RECORD OF DECISION TAKEN BY CORPORATE DIRECTOR

PROPOSED INTRODUCTION OF 20MPH SPEED LIMIT AND ASSOCIATED TRAFFIC CALMING MEASURES – MILE ROAD, WIDDRINGTON STATION

**C118 MILE ROAD, WIDDRINGTON STATION
TRAFFIC CALMING MEASURES**

FEASIBILITY AND OPTIONS REPORT

NOTES

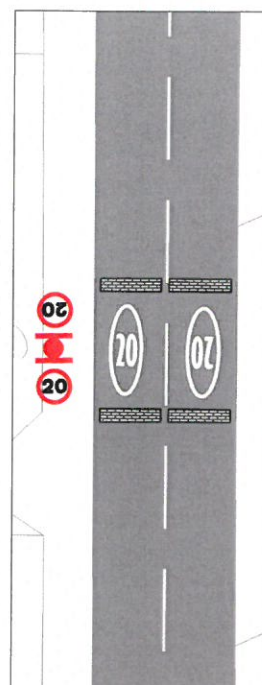
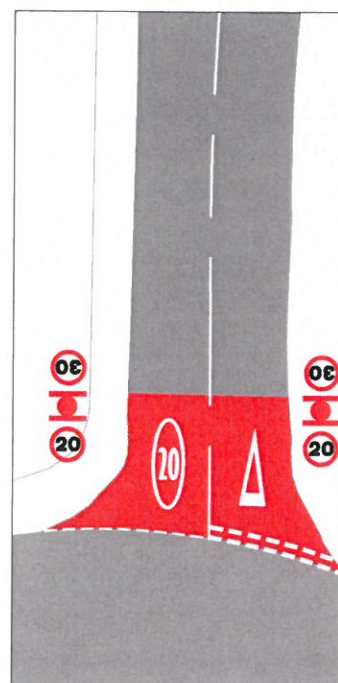
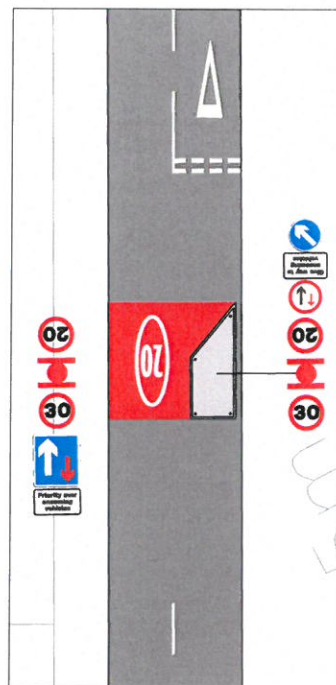
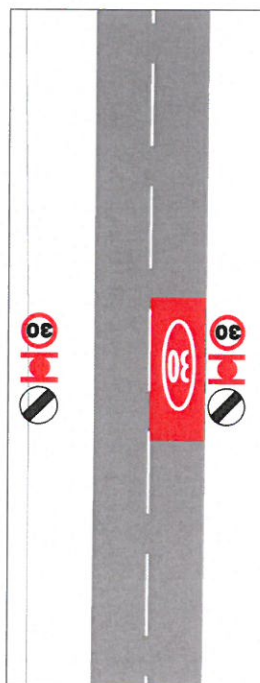
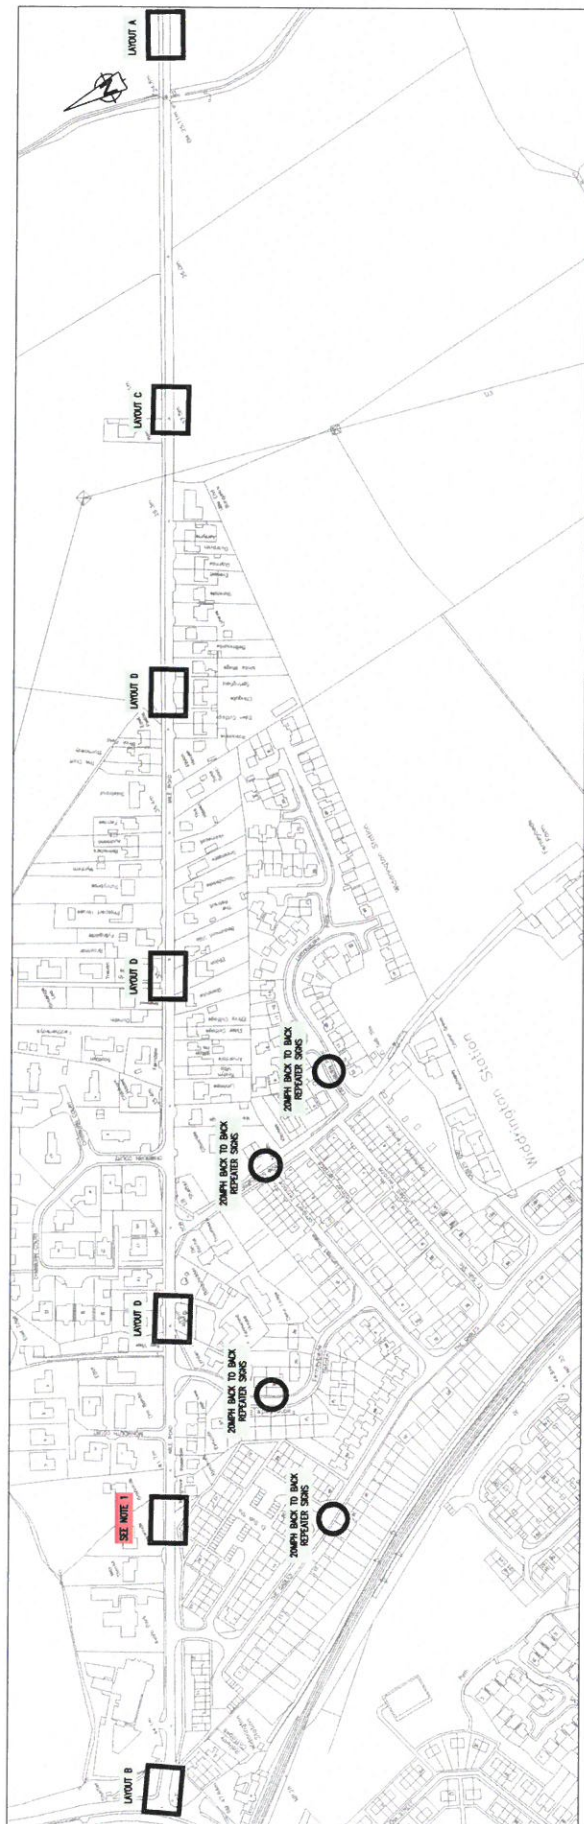
NE61 5QW	1		
NE61 5QW	1		
NE61 5QR	1		
NE61 5QW	1		
NE61 5QN	1		I support the proposals except for the quickset rumble strips. These have a limited effect and could cause a noise nuisance to properties near by, especially in quiet areas such as Mile Road.
NE61 5QW	1		Would like the 20MPH limit on Mile Road with Layout B & C. Don't agree with layout D with Rumble Strips.
NE61 5QW	1		With many of the houses on Mile Road having a high ledge adjacent to the carriageway (including my own) it is very important to limit vehicles to a speed at which prompt stopping is possible, some many vehicles have to pull out into the road before the driver can see oncoming traffic.
NE61 5QP	1		We would not support the proposed chicane in a future 2nd phase. A chicane would make it difficult for us to enter/exit our driveway, especially when the railway barrier had just been lifted when multi vehicles would be travelling down Mile Road. Also there is a proposed development of 4 properties opposite us at Oaklands with the potential of at least 10 vehicles our property without the introduction of a chicane which will exacerbate the problem. We feel that the introduction of a chicane at the proposed location will be a waste of public money as it is too near a T junction to have any effect.

NE61 5QL	1			I fully support the proposals to reduce traffic speed in this part of the village. My only disappointment is that you do not intend to proceed immediately with a chicane at the top end of the Mile Road. My house is close to the intended location of the chicane. My experience of traffic heading south along the road obtained is that as many as 1 in 20 vehicles reach excessive speed, above 40mph, by the time they pass my property. As your proposals stand there will be no physical constraint on vehicle speed until the rumble strip at Ferneybeds. I dont think this will be adequate to ensure vehicles reduce speed/adhere to the speed limit and may compromise the success of the scheme as it affects the Mile Road. As set out my view is that drivers will continue to accelerate excessively into the top of Mile Road I would be happier if there were some restraint near my property even if you consider the cost of a chicane is excessive to remind these drivers that they need to slow down.

NE61 5QL	1		We would like speed measures in place. There are too many motorists abusing the speed limit. There are driveways to homes right on to the road edge. There are a lot of elderly people, dogs, cars and children to be protected.
NE61 5QR	1		I strongly object to the inclusion of the proposed "Gateway Feature" (layout C on the plan). My property suffers from the worst of the speeding traffic, this gateway would push ALL traffic onto the north-side of the carriageway immediately outside my entrance. The clear line of sight up and down the road may even encourage traffic to speed up to get through the gateway before the opposing traffic, having a negative effect. Egress from Ramsey House would be very dangerous. I ask if before undertaking any road alterations outside my home you would consult me, I am sorry I was unable to attend the last meeting.
NE61 5QP			I have been away and returned to find the letter addressed to me at Estia, Mile Road, NE61 5QP. I realise that I have missed the deadline, but would support the following:- Provision of red traverse markings in advance of the 30 mph speed limit. A 20 mph speed limit if that is deemed appropriate. I do not see the necessity for gateways or chicanes. The sad fact is that most people speeding on mile road are residents of Widdrington who know full well the speed limit. I have noticed in other places that the signs that tell the actual speed of the car reminds drivers about the limit for a particular area. In addition, setting a speed trap once in a while would also assist.

NE61 5QR	1		
NE61 5RD		1	I am in favour of all of the traffic calming measures apart from the chicane (layout c). These are nothing more than an accident causing objects. You have to look no further than Ellington to Lynemouth. These are knocked down on a regular basis. Give the other measures a trial to see ow much they deter the excess speed. If negative then situate them.
NE61 5QR	1		The sooner the better.
NE61 5QW	1		
33	5	3

1. POTENTIAL LOCATION OF FUTURE (PHASE 2) CHICANE IF SPEEDING REMAINS A ISSUE.
